# USB Type-C ENGINEERING CHANGE NOTICE

**Title: Adapter Assembly Shielding Effectiveness**  
**Applied to: USB Type-C Cable and Connector Specification**  
**Release 1.2, March 25<sup>th</sup>, 2016**

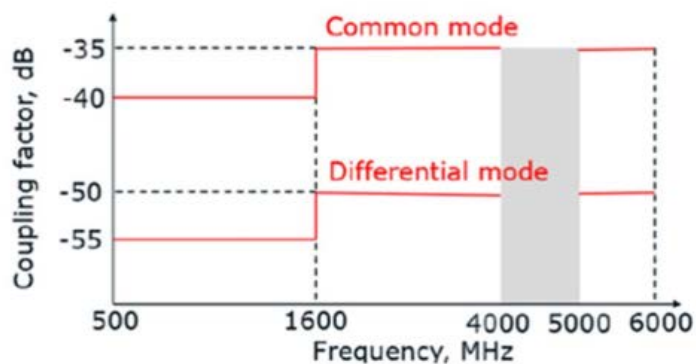
Measurement was done to evaluate the proposed change using compliance test fixture.
---

From Figure 3-56

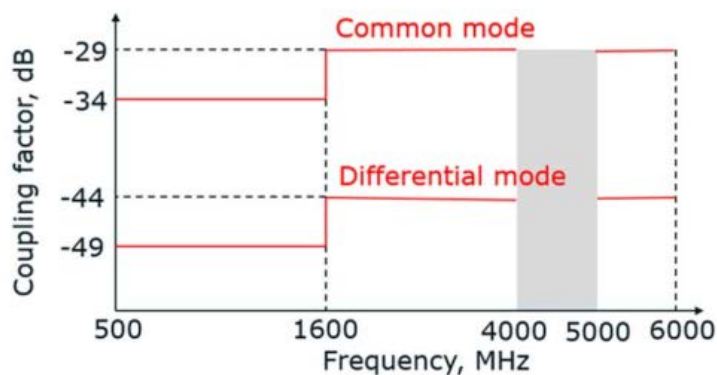
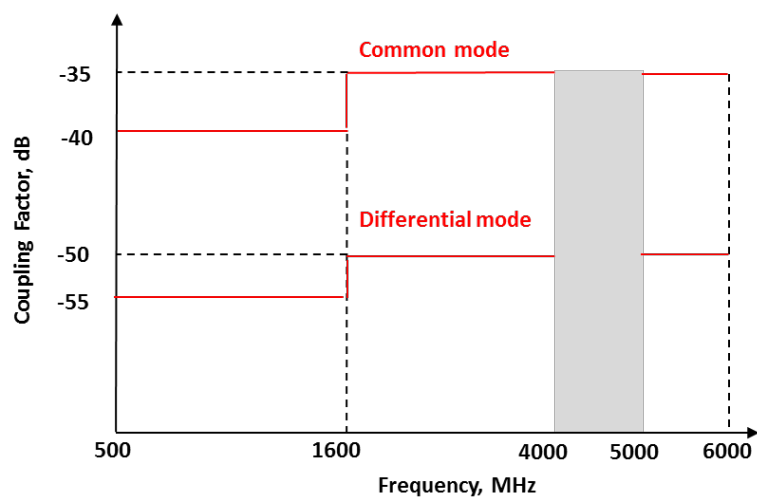
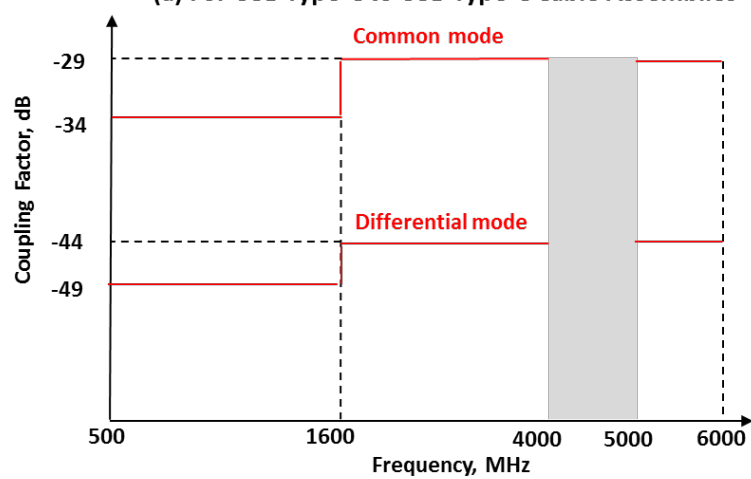
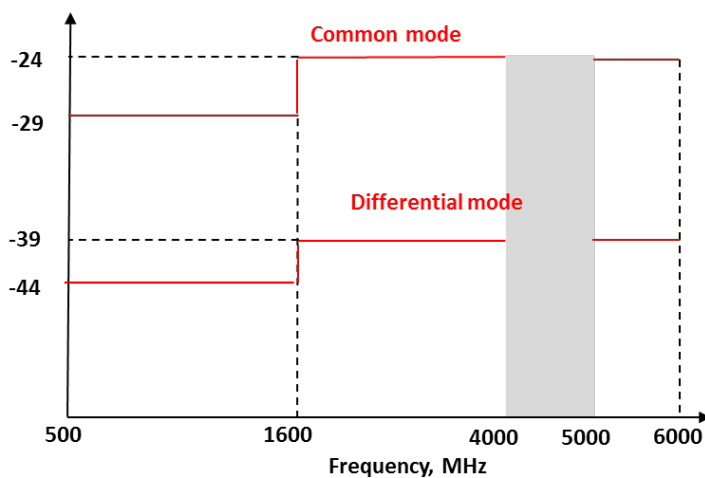
The change proposed to the specification is the addition of a shielding effectiveness requirement for USB Type-C to USB 3.1 Standard-A Receptacle Adapter Assemblies.
---

(a). Section 3.7.6, Page 97

To Figure 3-56:

(c) For USB Type-C to USB3.1 Standard-A Receptacle Adapter Assembly
